Comments on Camden Planning Application Ref: 2014/1598/P

Development at No.135 Fordwych Road, London NW2 3ND.

Ground Floor - Flat 1 (Continued)

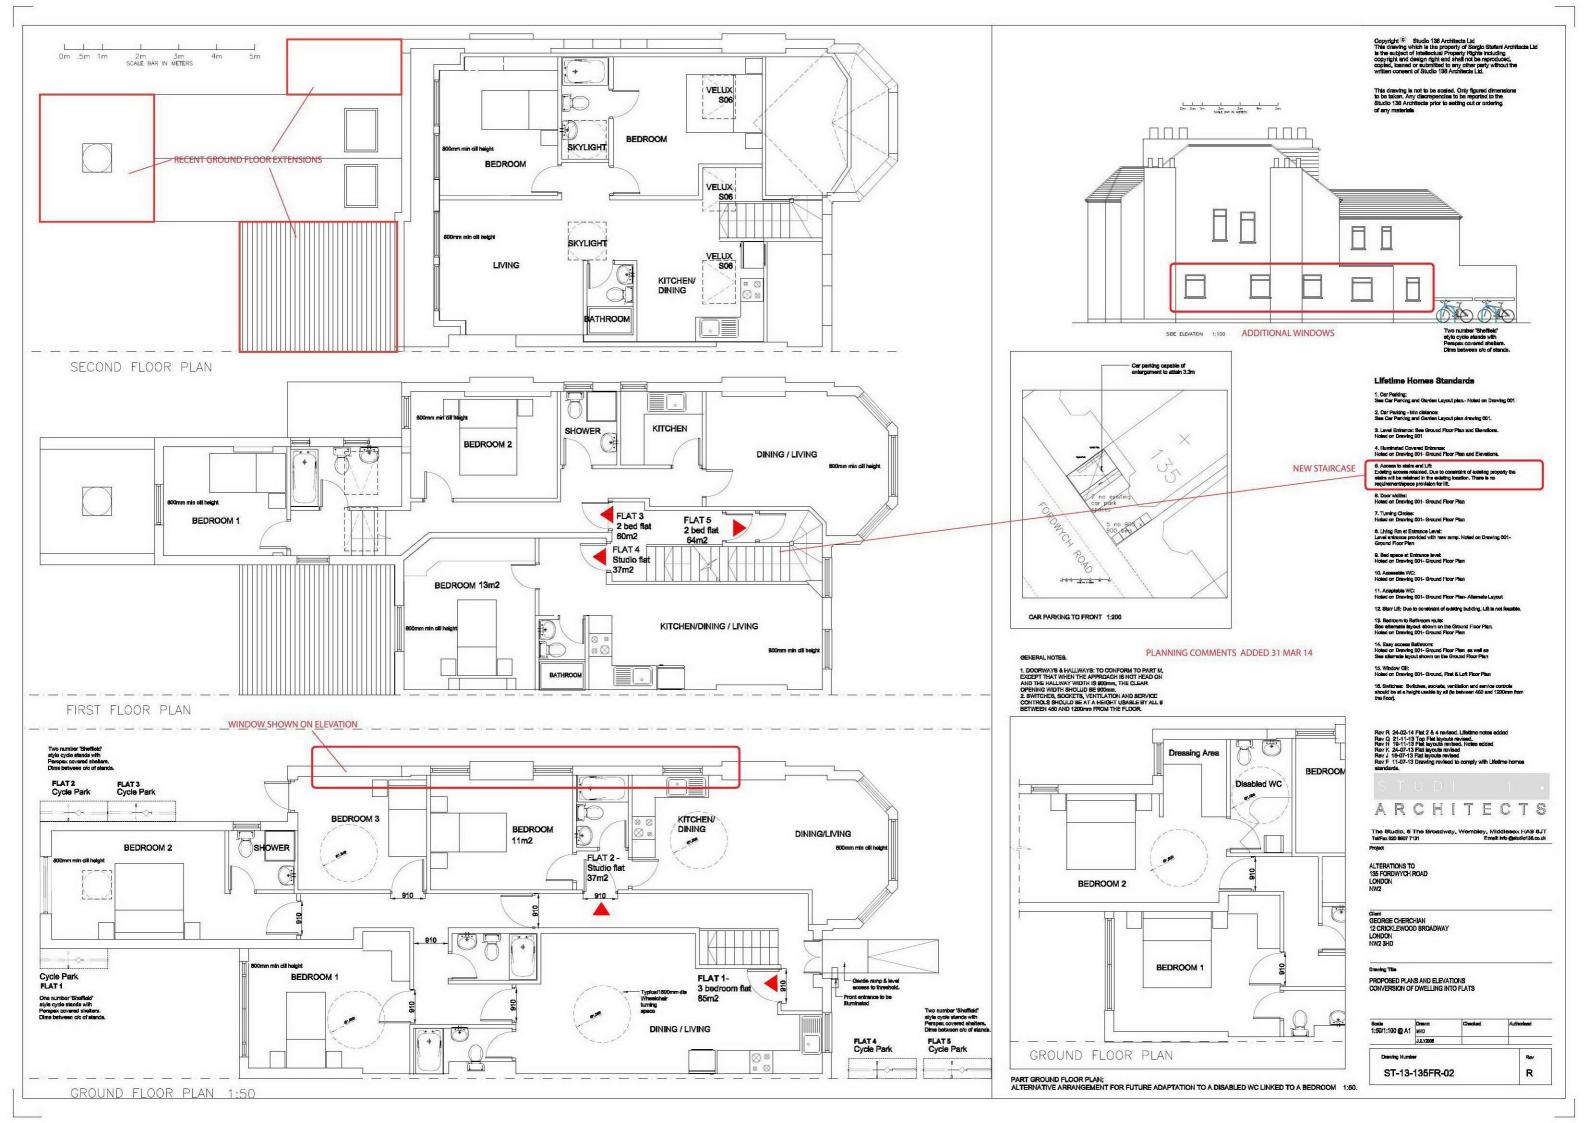
The Plan and Alternative Plan of Flat 1 Bedroom 3 does not show the window shown in the Side Elevation extension, which overlooks No 133 Fordwych Road to which the owners object.

The provision of 3 bathrooms for Flat 1 appears to be high, unless it is possibly intended to subdivide Flat 1 into two flats, at some future date?
